# Access Compliance Report

## Public Rights-of-Way

### (Curb Ramps)

Intersection ID: 15051	Main Street: FILLMORE_AV	Cross Street: KENILWORTH_AV	Location: S
ADA ID: D7C904EE2C06	Ramp Type: Directional1	Initial Pass/Fail: Fail	Overall Compliance: No
Codes/Mitigation Info/Possible Solution		Field Measurements/Component Compliance	
Severity Score: 13.75

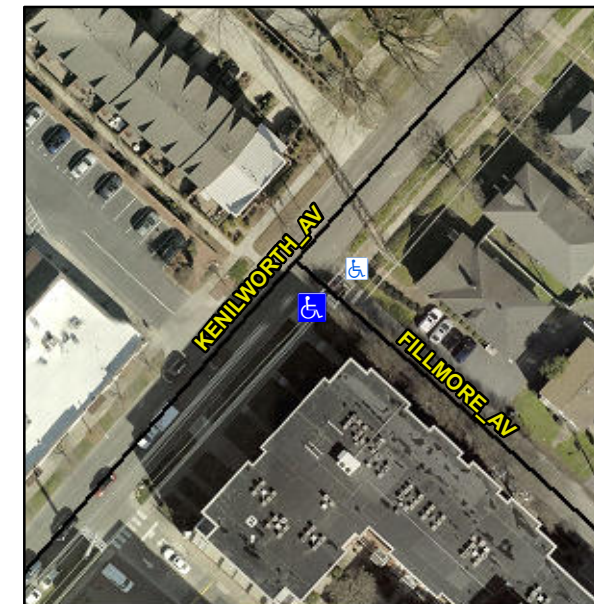
**UNMODIFIED CURB, CURB LIP 1.0"**

**R304.2.2, R304.5.3**

**Remove & Replace Entire Ramp.**
